Fincastle 336S Substation Upgrade

Alberta Utilities Commission

Decision 23393-D01-2019: Fincastle 336S Substation Upgrade

Proceeding 23393

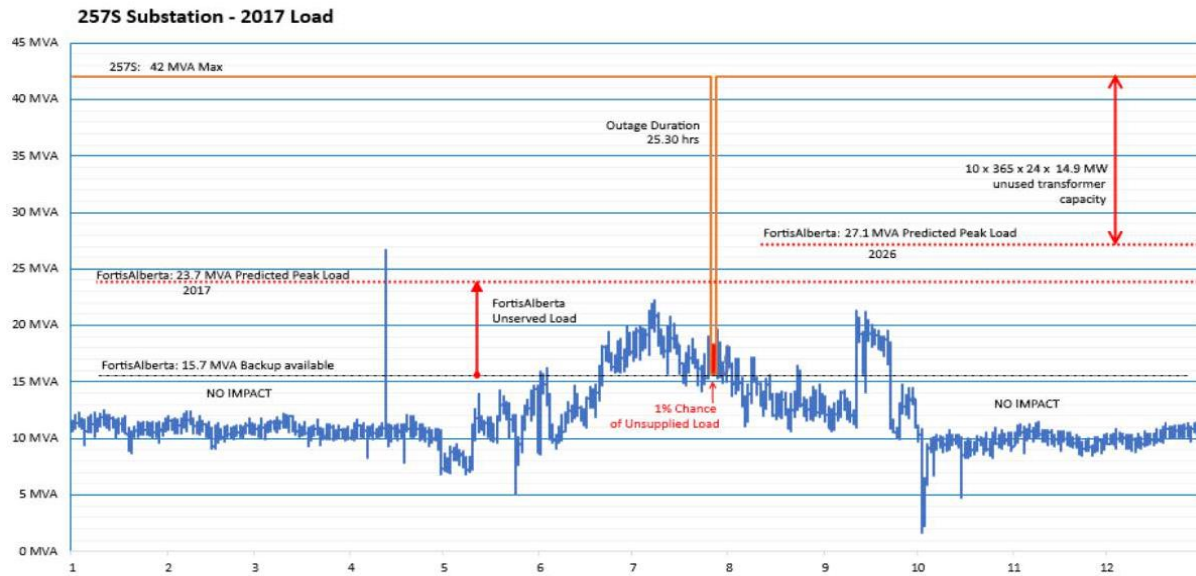
39. Aura conducted its own probabilistic modelling to assess the level of unsupplied load, if any, that would result from a transformer failure at the Fincastle 336S Substation. Aura examined a hypothetical outage at the Hull 257S Substation during July 2017, as follows:

The capacity at the Substation is 42 MVA and if a transformer were to fail, backup services from other proximate substations would provide 15.7 MVA of capacity. This is the N-1 capacity. The example shows that for most of this period of a few days in July, the load would be below the 15.7 MVA level and therefore, there would be no unsupplied load. In fact, given that load is typically lower outside of the summer months, the risk of

40. In response to an information request from the Commission, Aura clarified that the numbers 1 to 12 on the horizontal axis of the above chart represent the months of the year 2017, from January to December.²³

47. In response to Aura's argument that the likelihood of transformer failures is very small, FortisAlberta stated that Aura's table³⁰ and the outage frequency descriptive statistics therein are only based on transformer equipment subcomponents. FortisAlberta elaborated that the statistics do not account for failures in other equipment, such as terminal equipment, which could also result in a loss of supply from POD substations to the distribution system. FortisAlberta argued

that this omission is significant and materially skews the content in Aura's table. FortisAlberta stated that for 110 to 149-kV voltage class transformers, AltaLink statistics show that the inclusion of terminal equipment increases forced outage frequency by a factor of approximately 4.5.³¹
